Memorandum

RE: **P.Z. 13-2022 17955, 17965, 17985, and 17995 N. Outer 40 Rd. (Gateway Studios, LLC)**: A request for a zoning map amendment from the “M3” Planned Industrial District to “PC” Planned Commercial District for 77.8 acres located on the north side of Outer 40 Road (17W640035, 16W320011, 16W330021, and 16W320022).

Planning Commission Staff Report

RE: **PZ 13-2022 (Gateway Studios)** – Response Letter to Comments Raised at January 23, 2023
Public Hearing (Stock Project No. 222-7282)

Figure 4: Preliminary Development Plan

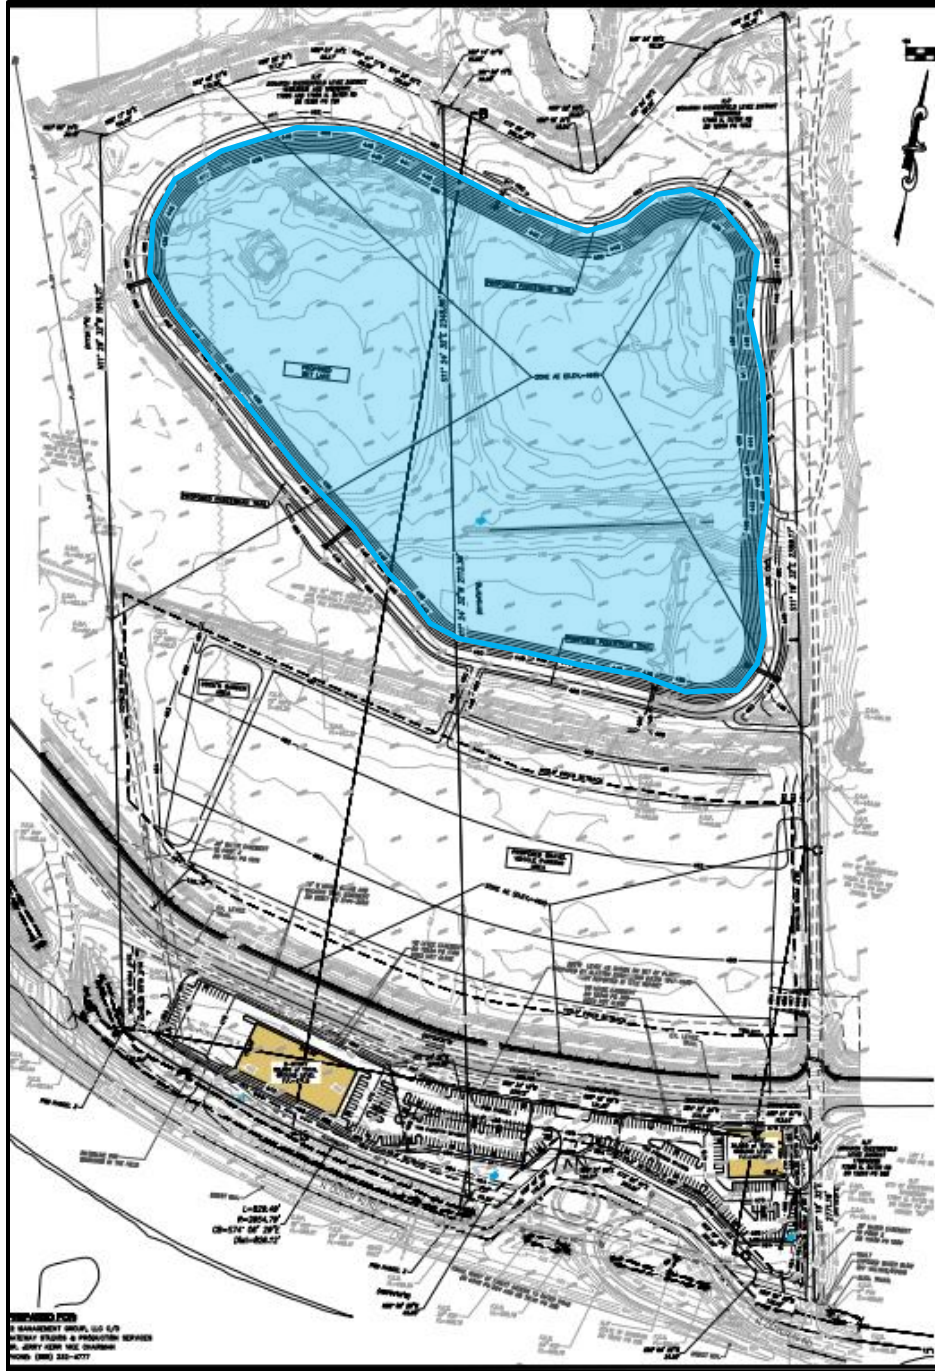
Concerns were raised regarding the following uses and their consistency with the Comprehensive Plan and adjacent land uses; Automobile Dealership; Oil Change Facility; Recreational Dealership; Motorcycle, ATV, and similar motor dealership; and vehicle repair and service facility were discussed. Please provide an explanation for requesting these uses.

Concern was raised regarding the size and material of the proposed gravel parking area to be located north of the levee trail including the amount of dust that may be generated from the gravel lot. Additionally, the City of Chesterfield Comprehensive Plan designates this area as "Conservation" and indicates properties within this designation should, "Limit impervious surface or encourage the use of stormwater BMPs." Provide information on how the development team will be addressing the above concern and consistency with Conservation land use designation.

Response: Applicant agrees to delete "Oil Change Facility" and "Repair and Service Facility". However, the applicant does believe the other "uses" built to an appropriate size, meeting the required setbacks and Openspace are viable for the Western Building similar to what is shown on the Preliminary Plan. It is feasible that a bicycle store with sales, leasing, and repair could occupy the Western Building as well.

Response: We understand the Comprehensive Plan Designation. It is our understanding that the Planning Commission discussed in 2022. This property and the general consensus was, "Development" as Regional Commercial Designation would be appropriate.

The gravel lot is being placed at elevation 451-453.50, the Trail on Top of Levee is elevation 477.00 (23.50-25.50 Higher) and is approximately 120-155 feet north of the trail. The proposed Lake will replace Borrow Pits, the addition of a Trail, and Cook's Garden are all consistent with conservation and passive recreation. The use of gravel is the only material that is manageable and sustainable within the 100-year floodplain. Similar to another approved project within the valley, the application of Calcium Chloride was approved by the Planning Commission as a Dust Control Product. This product if Environmentally Sensitive may be used on this project or an equal product that is environmentally sensitive applications. The maximum size of the overflow lot has been modified (made smaller) to accommodate the location of the Cook's garden at the West end of the lot.

SHEET TITLE:
PRELIMINARY DEVELOPMENT PLAN

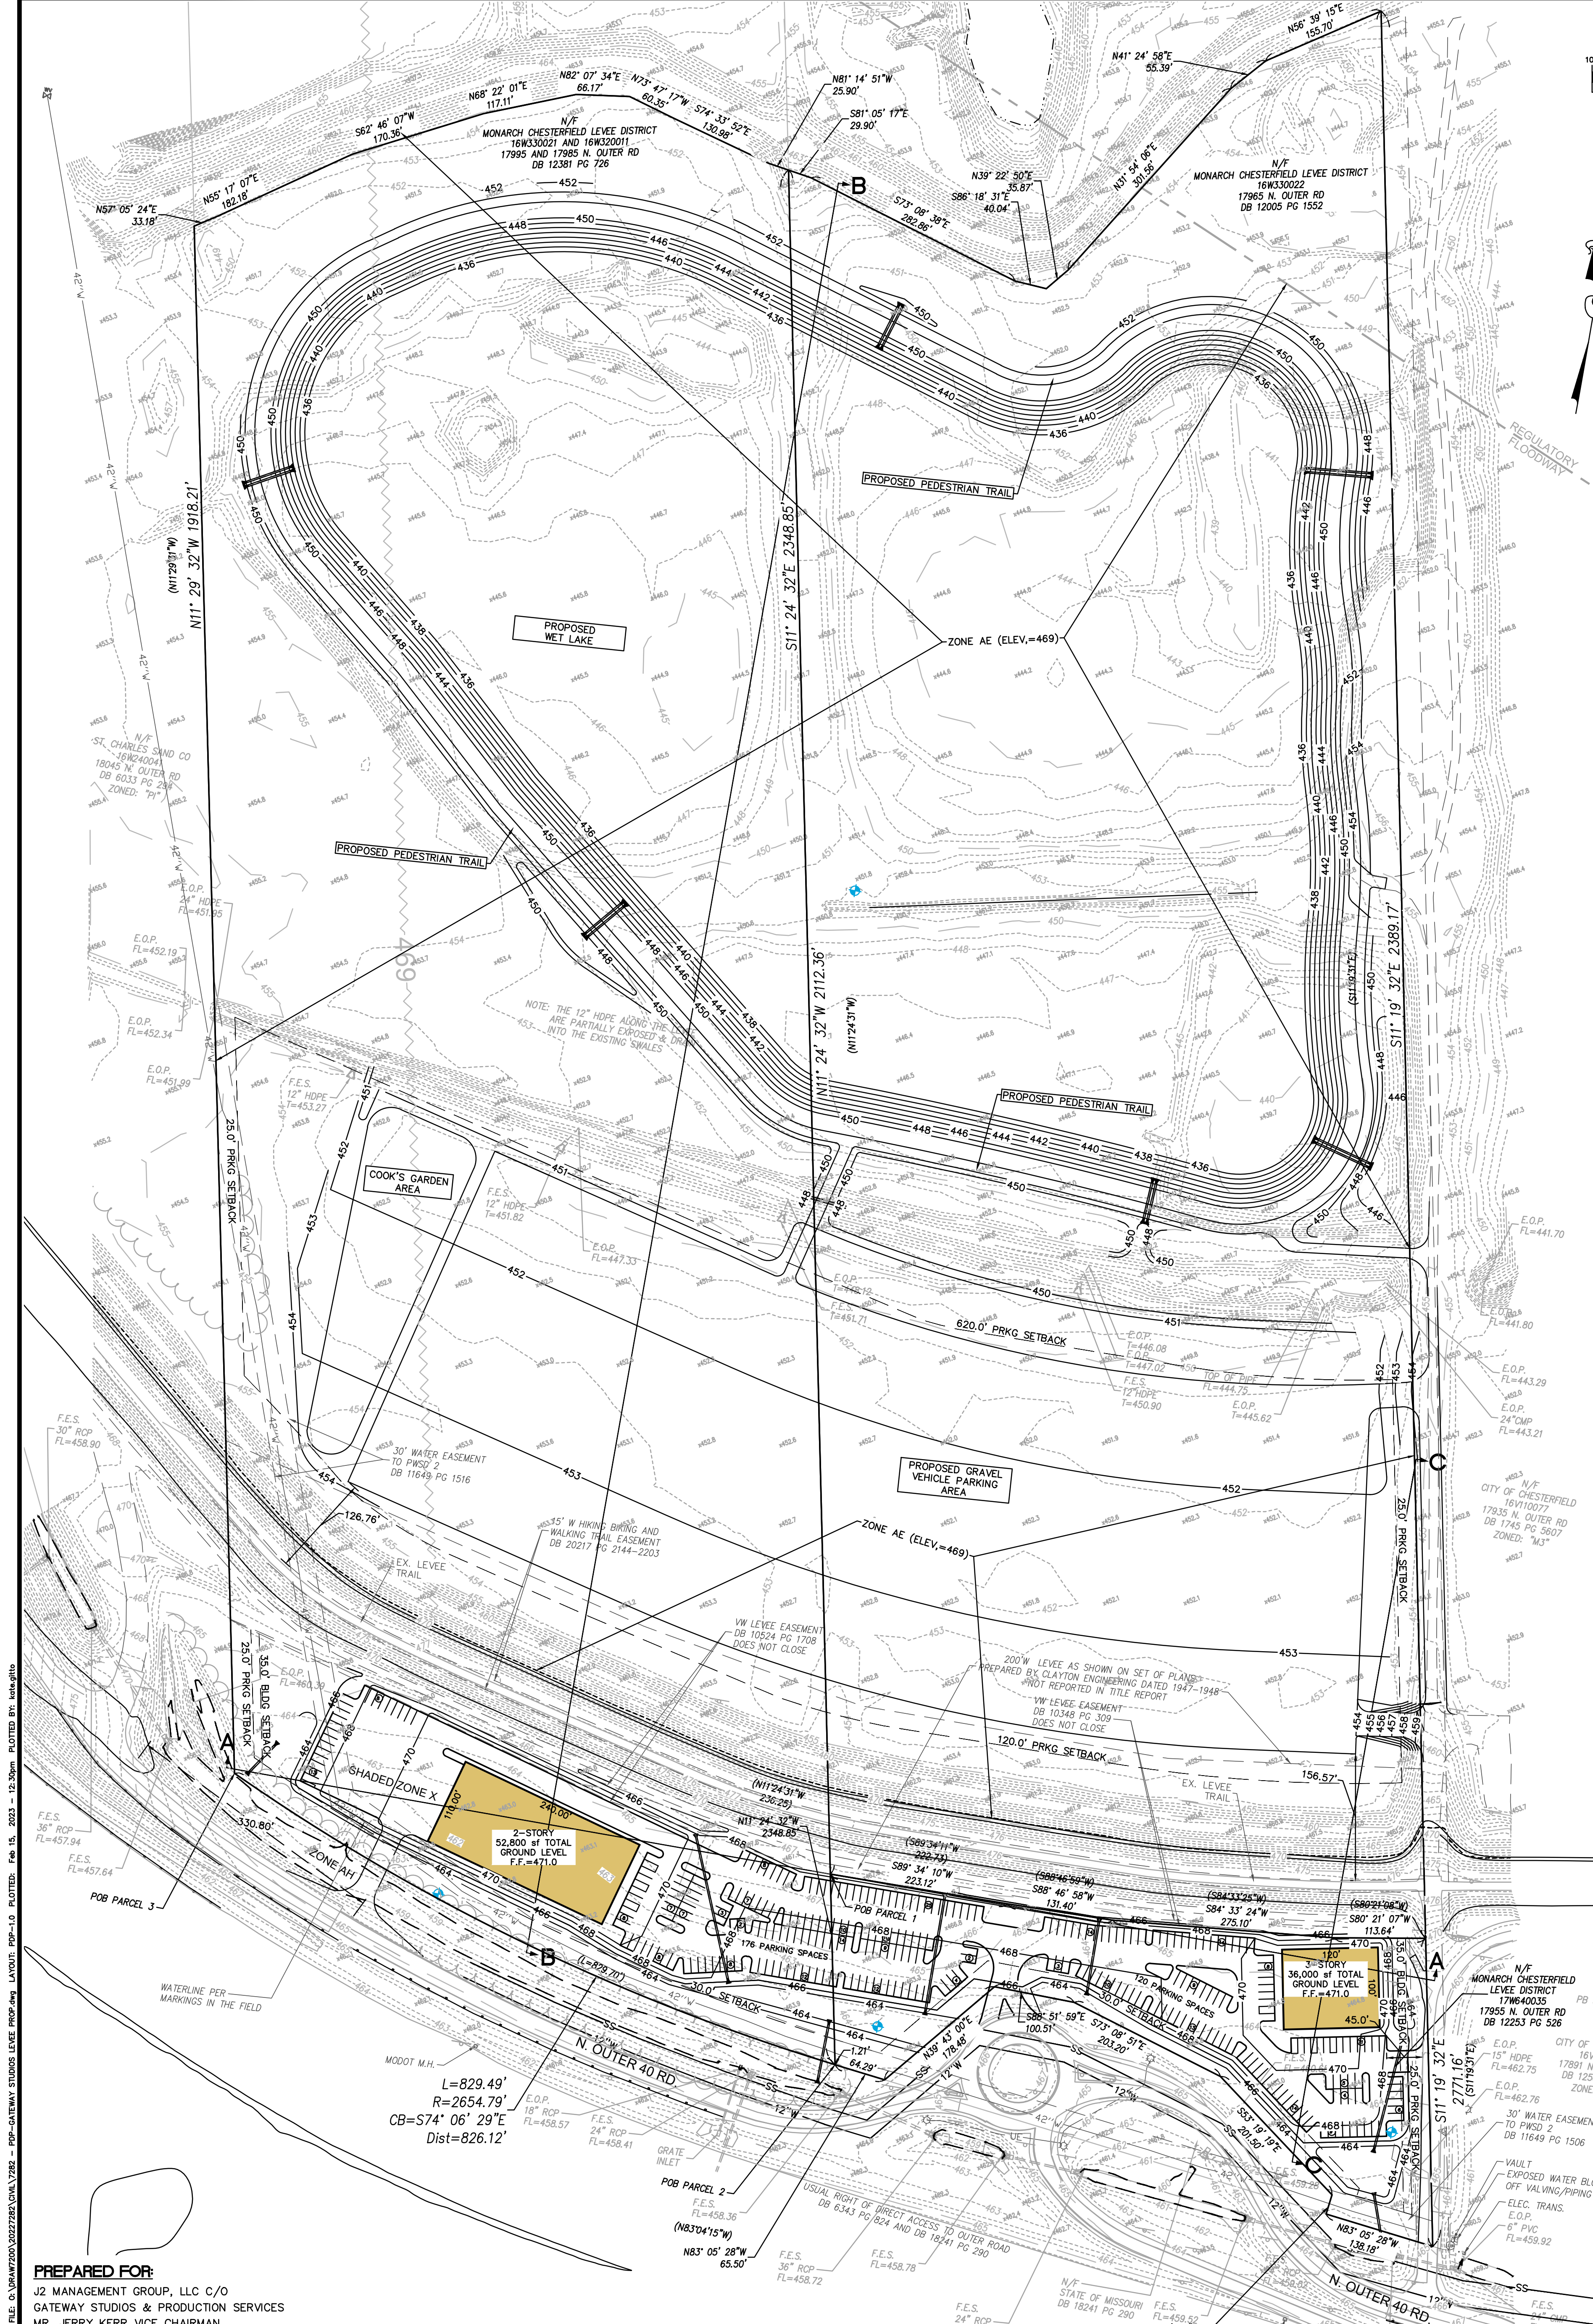
3. Provide the parking setbacks located to the north of the Levee Trail.

4. Show all the setback lines on the Preliminary Development Plan.

5. Indicate boundaries of SFHA, Floodway and SPA on the Preliminary Plan.

6. Based on information provided it is understood that large vehicles will utilize the parking area north of the levee. Confirm that these vehicles can cross the levee and levee trail without being high centered. Additionally, provide information on the frequency and volume of vehicles that are anticipated to cross the levee and suitability of the existing improvements based on the site, weight, and volume of vehicles crossing at this location.

Response: Added to Plan.

Response: Added to plan.

Response: Added to plan.

Response: Attached is an exhibit of a WB-67 Vehicle Driving over the levee, it clears by 0.95 feet. The frequency is not known at this time, but as indicated at the Public Hearing it's primary use is for special events. All necessary materials and soil testing of Access Road will be performed and considered at the time of a Site Development Section Plan and Site Improvement Plans associated with approval of the Gravel Overflow Lot.
